Intel[®] Celeron[®] Processor Specification Update

Release Date: April 2008

Document Number: 243748-052

The Intel[®] Celeron[®] processor may contain design defects or errors known as errata, which may cause the product to deviate from published specifications. Current characterized errata are documented in this Specification Update.

Figure 1 Celeron® on 0.13 Micron Processor 256K Platforms Workaround

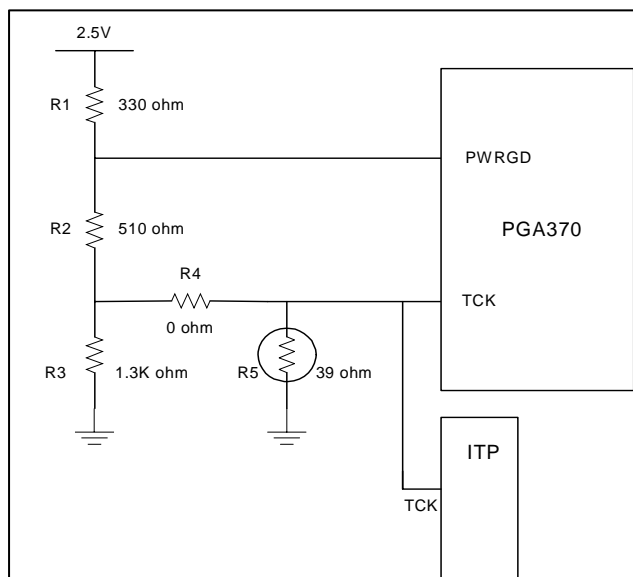
Workaround: To prevent the risk of power-on boot failures or catastrophic thermal failures, a platform workaround is required. The system must provide a rising edge on the TCK signal during the power-on sequence that meets all of the following requirements:

Please note, the example workaround circuits attached require circuit modification for ITP tools to function correctly. These modifications must remove the workaround circuitry from the platform and may cause systems to fail to boot. Review the accompanying notes with each workaround for ITP modification details. If the system fails to boot when using ITP, issuing the ITP 'Reset Target' command on failing systems will reset the system and provide a sufficient rising edge on the TCK pin to ensure proper system boot.

In addition, the example workaround circuits shown do not support production motherboard test methodologies that require the use of the processor JTAG/TAP port. Alternative workaround solutions must be found if such test capability is required.

For Production Boards:
Depopulate R5
